Access Compliance Report

Public Rights-of-Way

(Curb Ramps)

Intersection ID: 14501	Main Street: BALDWIN_AV	Cross Street: ELLISON_ST	Location:	N
ADA ID: 529DC6D7246F	Ramp Type: PerpDiag	Initial Pass/Fail: Fail	Overall Compliance: No	Severity Score: 12.5

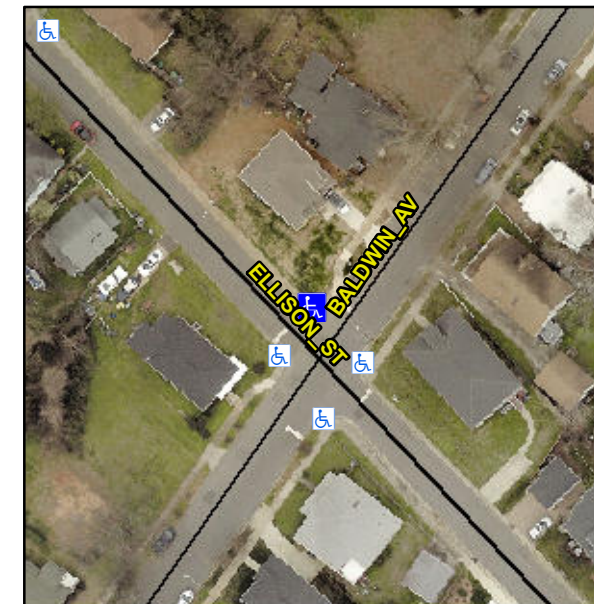
Not Found, R304.2.2

Compliance	Description	Data	Compliance	Description	Data
N/A	Ramp Length (in)	59.0	No	Ramp Slope (%)	11.0
Yes	Ramp Width (in)	48.0	Yes	Ramp XSlope (%)	0.5
N/A	Flare Type LT	N/A	N/A	Flare Type RT	N/A
N/A	Flare Slope LT (%)	N/A	N/A	Flare Slope RT (%)	N/A
N/A	Flare Traversable LT?	N/A	N/A	Flare Traversable RT?	N/A
N/A	Landing Length (in)	N/A	N/A	DWS Provided?	N/A
N/A	Landing Width (in)	N/A	N/A	DWS Contrast?	N/A
N/A	Landing Slope (%)	N/A	N/A	DWS Length (in)	N/A
N/A	Landing X Slope (%)	N/A	N/A	DWS Full Width?	N/A
N/A	Landing Curb? (Y/N)	N/A	N/A	DWS Offset (in)	N/A
N/A	Shared Landing?	N/A			
N/A	Gutter Ponding?	N/A	N/A	Gutter Slope (%)	N/A
N/A	Gutter Lip Ht (in)	N/A	N/A	Gutter X Slope (%)	N/A
N/A	Painted X Walk1?	No	N/A	Painted X Walk2?	No
	X Walk 1 Direction	To SW		X Walk 2 Direction	To SE
N/A	X Walk 1 Width (in)	N/A	N/A	X Walk 2 Width (in)	N/A
	X Walk 1 Slope (%)	1.4		X Walk 2 Slope (%)	1.1
	X Walk 1 X Slope (%)	0.4		X Walk 2 X Slope (%)	1.5

Remove & Replace Curb Ramp With Two New Directional Ramps or Equivalent.
